Eddy Building – Detached Addition : Addendum #5

DATE: October 23, 2024

Hobbs Architects, PA
159 West Salisbury Street
PO Box 1457
Pittsboro, North Carolina 27312

ADDENDUM #5:

DATE 9/6/24
A-502 ALT

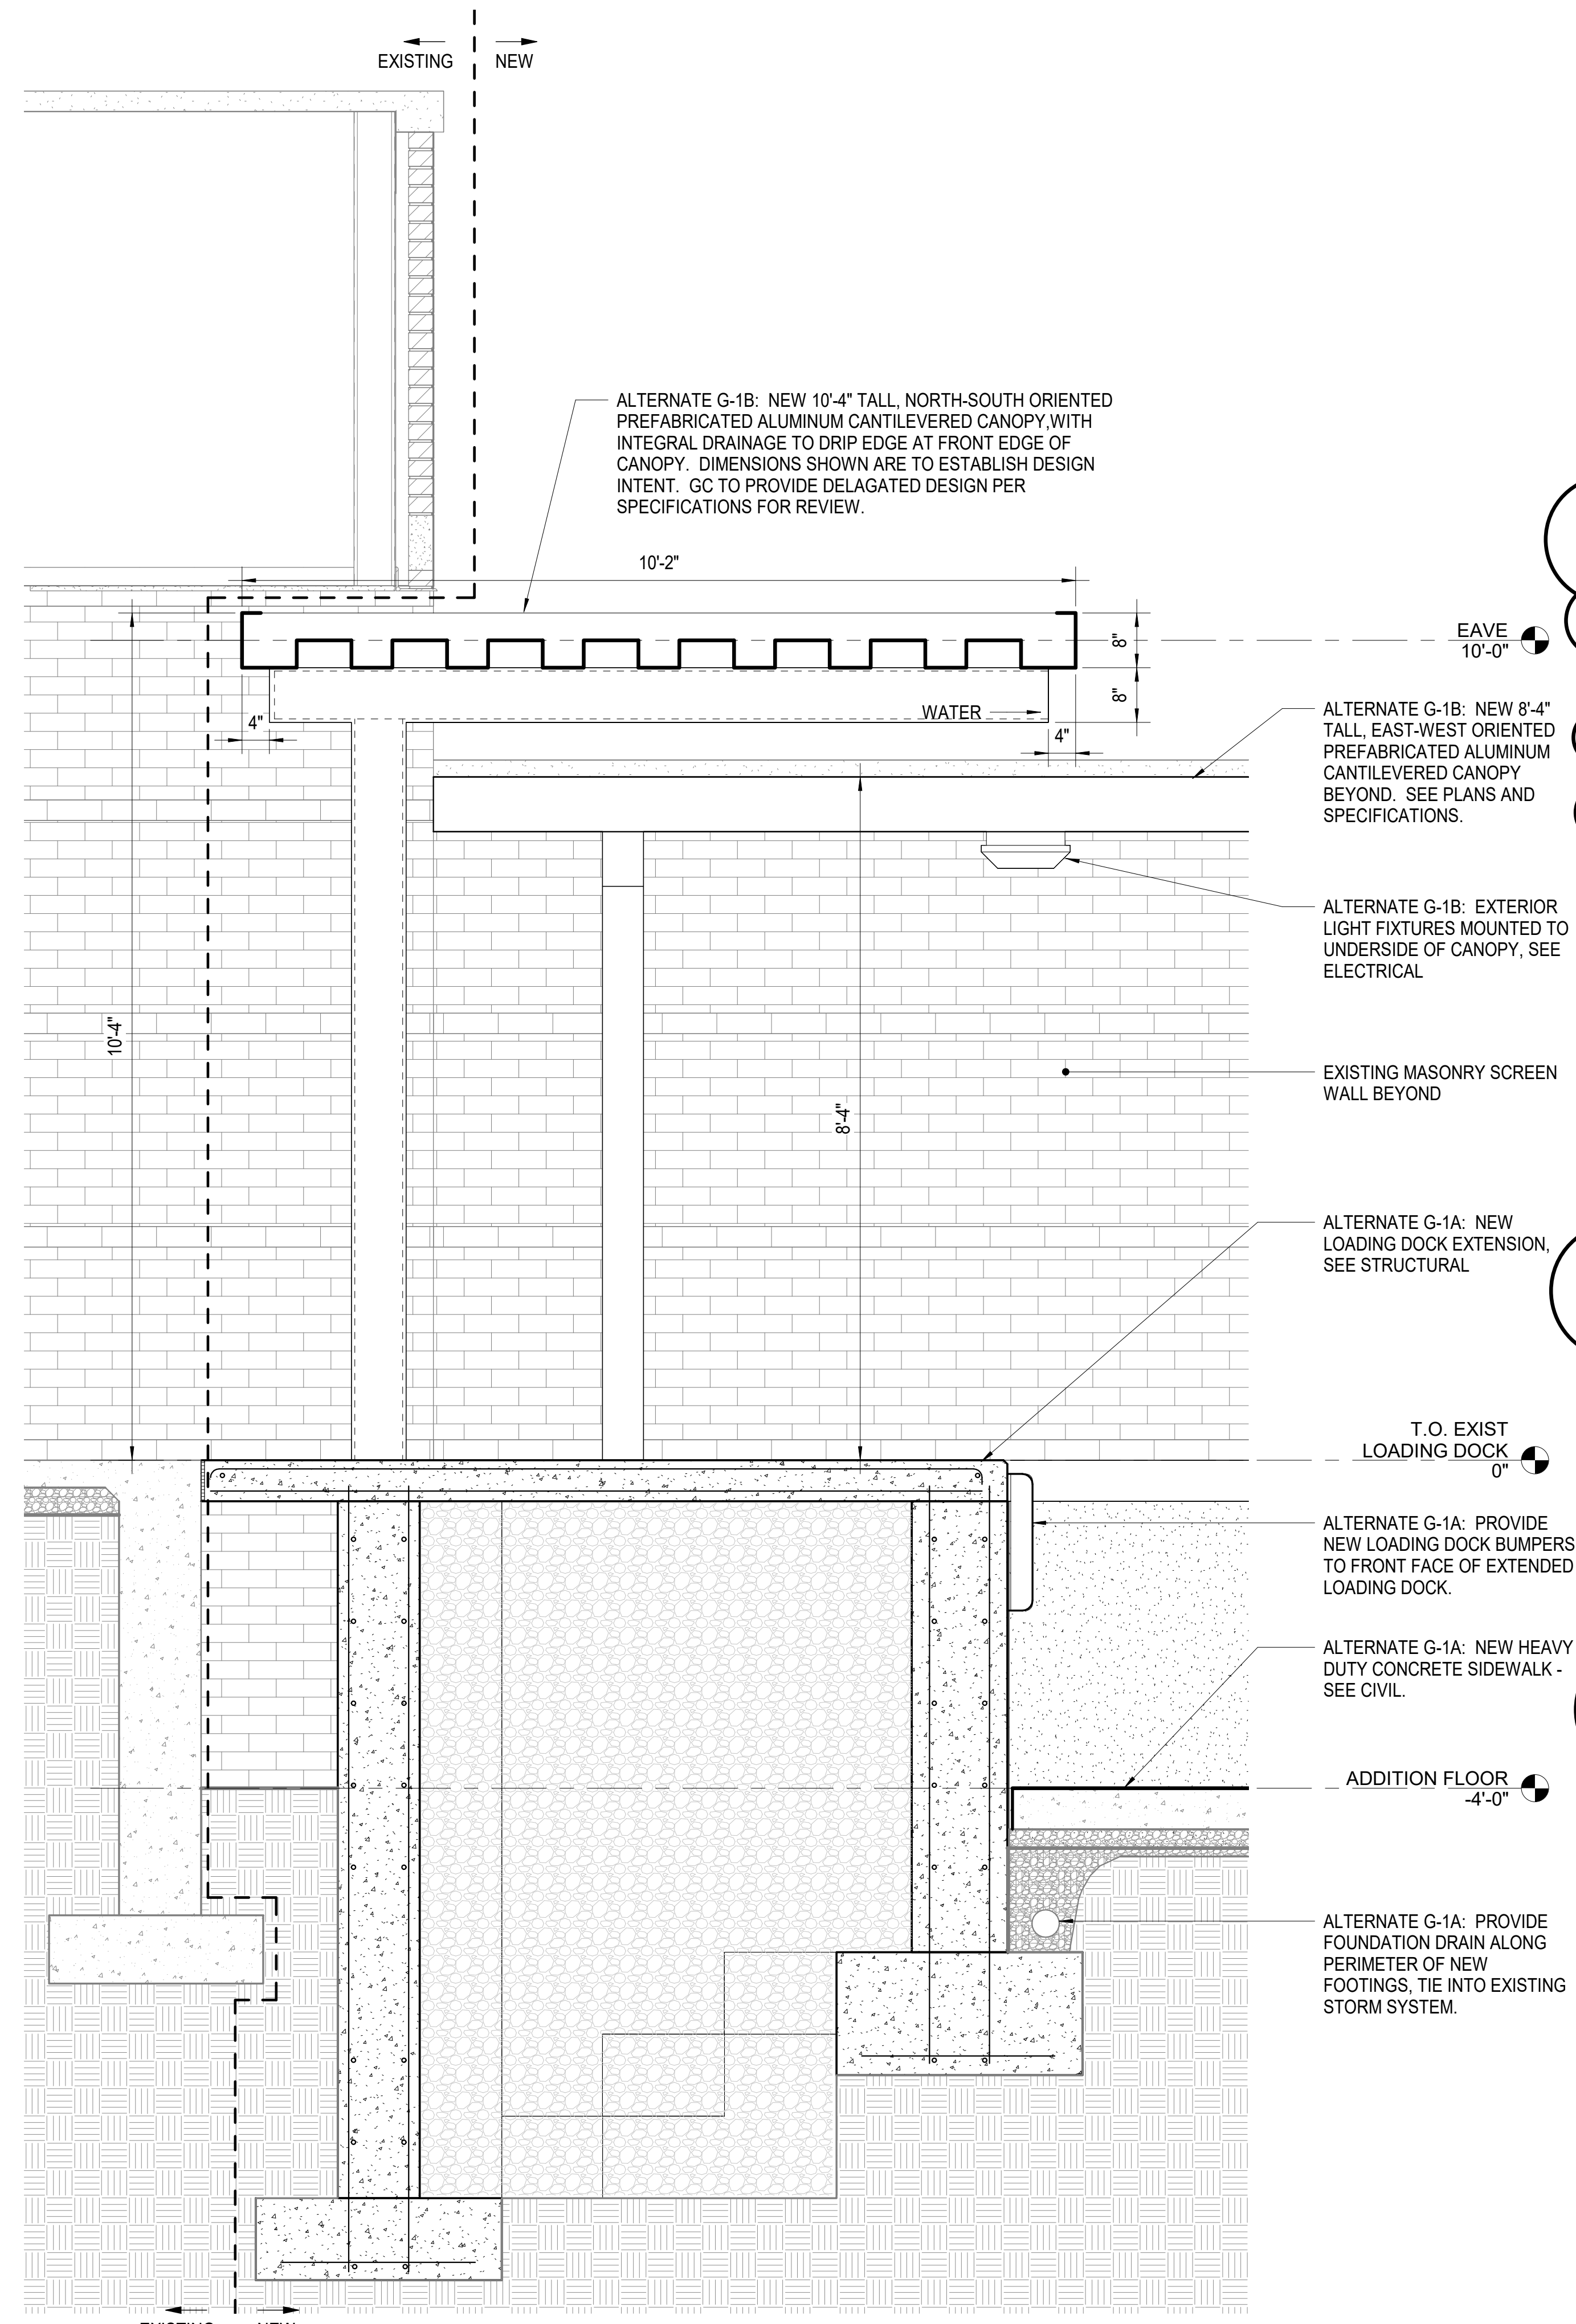
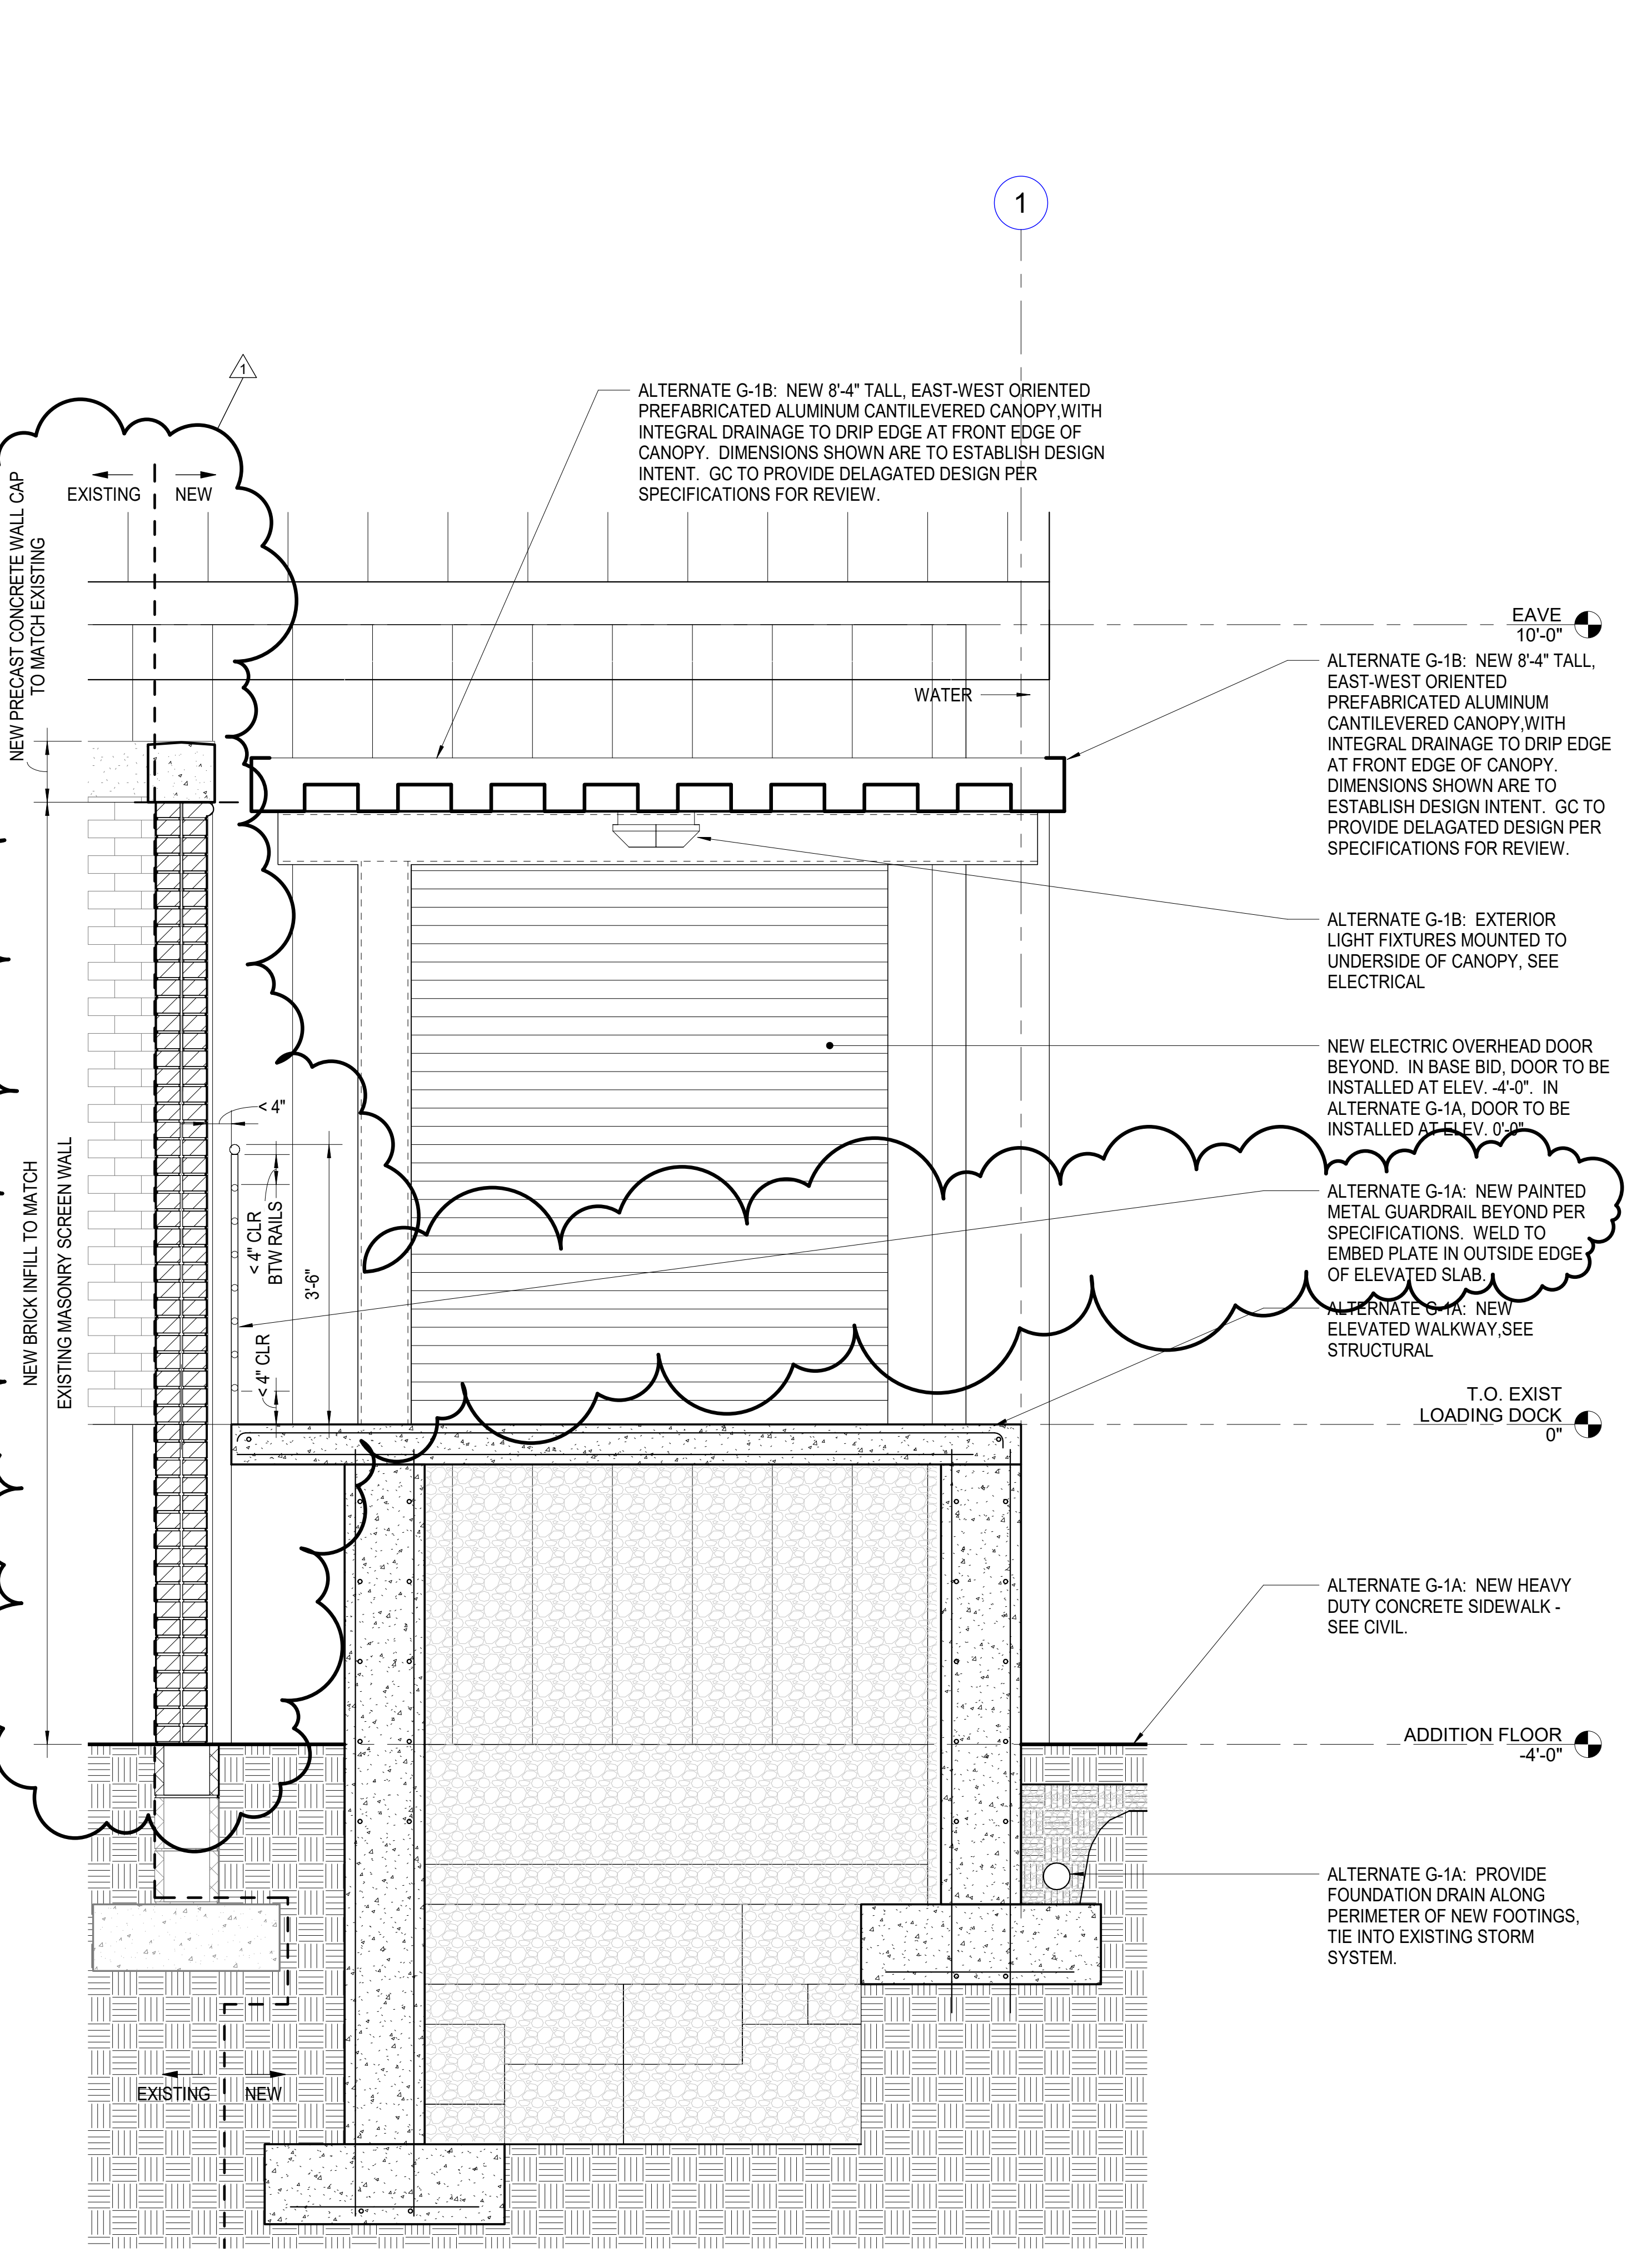
10. Please provide additional details and clarification to the removal of the gate and infill of the masonry screen wall. The drawings only note the gate removal and show the infill as all brick infill for an opening that is roughly 9'-4" x 4'-3". As shown in the attached pictures, this gate is the full height of the screen wall and also has a concrete knee wall and precast concrete cap. Please clarify what the intent is for the infill and provide additional details as necessary.

1. RESPONSE: See updated sheet A-302 ALT and A-502 ALT included in this addendum.
11. General note 5 on sheet E-101 states that automated lighting controls are not include inside the building due to safety concerns. Does this include the astronomical time clock that is tied to the exterior type C light fixtures? Or should that be included in our bid?

2 CANTILEVERED BENT CANOPY SECTION AT MECH YARD - BASE BID + ALTERNATES
SCALE: 3/4" = 1'-0"
